SUNDRY NOTICES AND REPORTS ON WELLS
Do not use this form for proposals to drill or to re-enter an abandoned well. Use form 3160-3 (APD) for such proposals.

8. Well Name and No.
CASE B 21

P&A Procedure

CONDITIONS OF APPROVAL

Proposed P&A

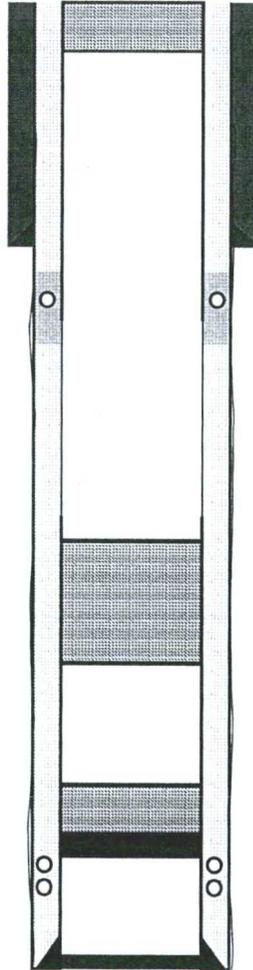
1. Plugging operations authorized are subject to the attached "General Requirements for Permanent Abandonment of Wells on Federal and Indian Lease."
2. Farmington Office is to be notified at least 24 hours before the plugging operations commence (505) 564-7750.
3. The following modifications to your plugging program are to be made:
 - a) Set Plug 1 (2473 – 2294) ft. to cover the Fruitland top. BLM picks top of Fruitland at 2344 ft.
 - b) Set Plug 2 (1223 – 976) ft. to cover the Kirtland top. BLM picks top of Kirtland at 1173 ft.
 - c) Set Surface Plug (298 – 0) ft. to cover the 8-5/8" casing shoe. Surface casing shoe at 248 ft.

Operator must run a CBL to verify cement top. Submit the electronic copy of the log for verification to the following addresses: jwsavage@blm.gov Brandon.Powell@state.nm.us
